FOR ALL VAULT TOILET REPLACEMENT CONTRACTS

MULTIPLE STATE FOREST CAMPGROUNDS

DNR PROJECT No. 26-3953, 1 - 8

ADDENDUM No. 1

SILT FENCE
DETAIL

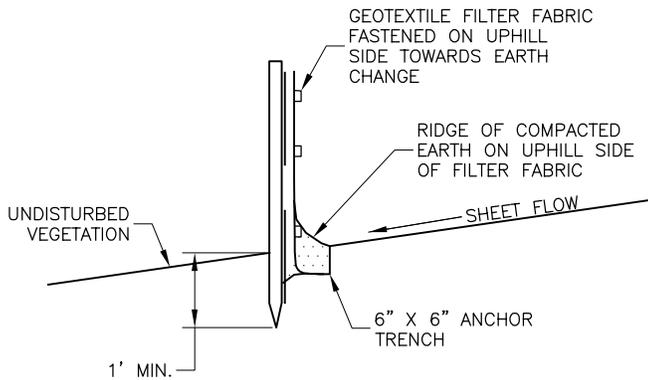
ITEM #3: Silt Fence: Silt fence shall be required around disturbed construction areas as detailed in the attached drawing.

NOTE: ON ALL DEMOLITION AND NEW CONSTRUCTION A MINIMUM OF 15 LINEAL FEET OF SILT FENCE TO BE CONSTRUCTED ON THE DOWNWARD SLOPE IN THE AREA OF VAULT TOILET.

1. INSTALL PARALLEL TO A CONTOUR.
2. SILT FENCE SHALL BE MADE OF WOVEN GEOTEXTILE FABRIC.
3. DIG A 6" TRENCH ALONG THE AREA WHERE THE FENCE IS TO BE INSTALLED.

4. PLACE 6" OF THE SILT FENCE BOTTOM FLAP INTO THE TRENCH.
5. BACKFILL THE TRENCH WITH SOIL AND COMPACT THE SOIL ON BOTH SIDES. CREATE A SMALL RIDGE ON THE UP-SLOPE SIDE OF THE FENCE.

6. 6. INSTALL WOODEN STAKES 6 - 10' APART AND DRIVE INTO THE GROUND A MINIMUM OF 12".
7. STAPLE THE GEOTEXTILE FABRIC TO THE WOODEN STAKES.
8. JOIN SECTIONS OF SILT FENCE BY WRAPPING ENDS TOGETHER (SEE DRAWING).

9. INSPECT FREQUENTLY AND IMMEDIATELY AFTER EACH STORM EVENT. CHECK SEVERAL TIMES DURING PROLONGED STORM EVENTS. IF NECESSARY, REPAIR IMMEDIATELY.
10. IF THE SEDIMENT HAS REACHED 1/3 THE HEIGHT OF THE FENCE, THE SOIL SHALL BE REMOVED AND DISPOSED OF IN A STABLE UPLAND SITE.

11. THE FENCE SHALL BE RE-INSTALLED IF WATER IS SEEPING UNDERNEATH IT OR IF THE FENCE HAS BECOME INEFFECTIVE.
12. SILT FENCE SHALL BE REMOVED ONCE VEGETATION IS ESTABLISHED AND UP-SLOPE AREA HAS STABILIZED.
